Advice on Environmental and Social Impacts Associated with the Proposed Gulpur Hydropower Project, State of Azad Jammu & Kashmir

Advisory Report by the Dutch Sustainability Unit

Subject: Advice on Environmental and Social Impacts Associated with the Proposed Gulpur Hydropower Project, State of Azad Jammu & Kashmir, Pakistan

Reference: SU01-69

Figure 2: Length of River Affected: Option1 and Option 3

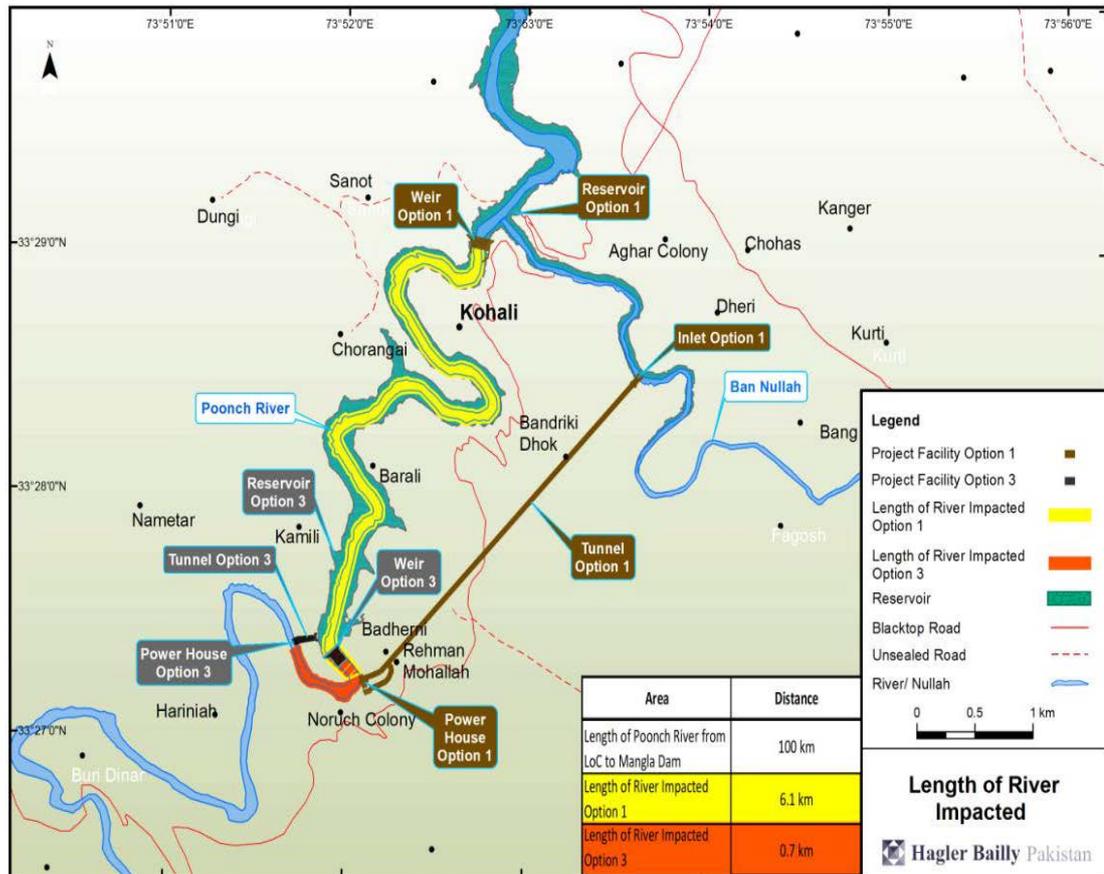
Figure 2 indicates the main design differences between Option 1 and Option 3. (Option 2 was an intermediate configuration in terms of the location of the dam and the tunnel. Compared to the other two options it was found not to be technically feasible, and did not offer any significant socioeconomic advantage over Option 1 and was therefore dropped early in the analysis). As can be seen from Figure 2, Option 3 results in a much

smaller length of impacted river.

Figure 4: Loss in Revenue and Survival of Fish

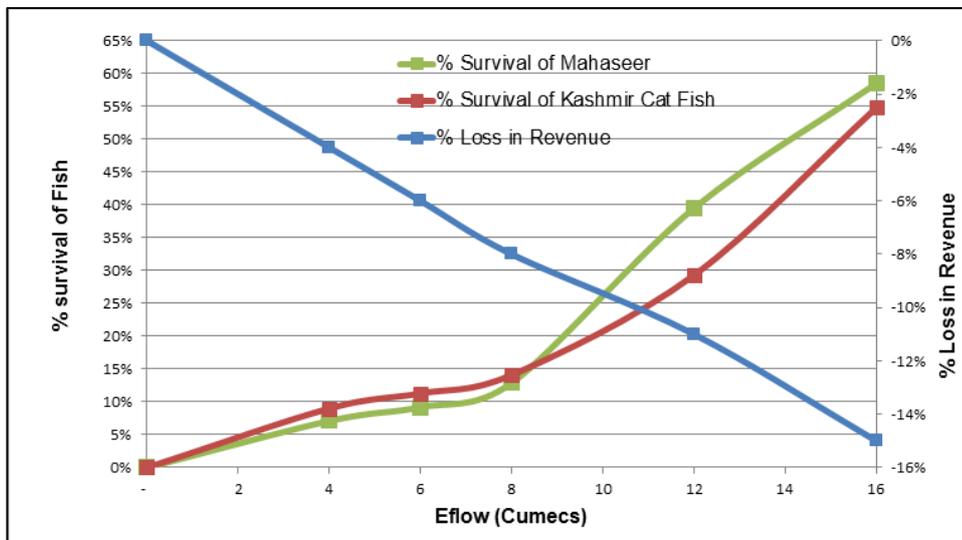
An important result of the EFlow assessment is shown in Figure 4 where “loss of ecosystem services” can be compared against “loss in revenue”. Decision makers can then take a decision on acceptable environmental loss/degradation against project cost. An EFlow of 4 m³s⁻¹ was set after discussion with stakeholders, including those in affected communities. This turned out to be on the lower side of the range considered. The main reason for this was that the principal improvement in river environmental quality is achieved through protection by putting in place a good management programme (i.e. the Protection Scenario under the BAP). Releasing additional flow from the dam at the expense of power generation is of marginal value in comparison to this.

Figure 5: Ranking of Cumulative Impacts on the Ecology of AJK Rivers and Streams

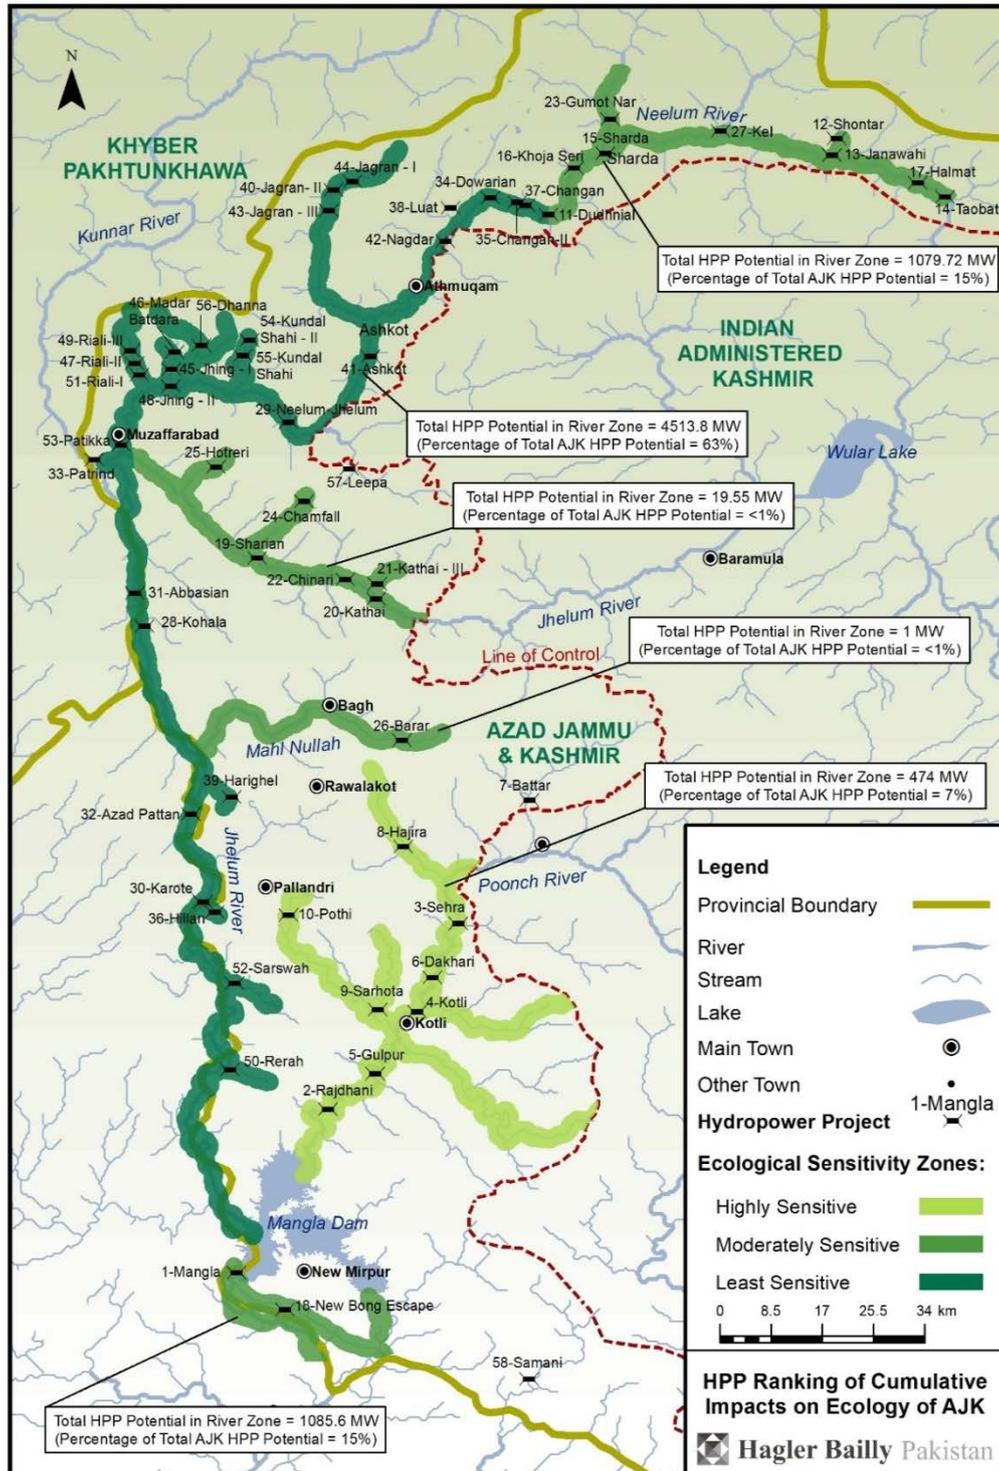
An strategic environmental assessment (SEA) of hydropower planning in AJK was undertaken by IUCN in 2013³. This study mapped all known hydro projects proposed by the Water and Power Development Authority (WAPDA), the Private Power and Infrastructure Board (PPIB), the Hydroelectric Board (HEB), and the Private Power Cell (PPC). It then undertook a detailed analysis of the environmental and social sensitivity of rivers and nullahs (streams) where the dams were proposed. The outcome of this analysis is presented in Figure 5. It shows that the Poonch River and its tributaries is the most ecologically sensitive river in AJK, and that the proposed Gulpur Hydropower Project is ranked fifth in terms of its ecological impact. An equivalent ranking study of possible socio-economic impacts resulted in a similar outcome for the Poonch River, and for the GHP.

Conclusion:
 There are, according to a strategic environmental assessment, other rivers in AJK that have greater overall hydropower potential and with comparatively lower environmental costs.
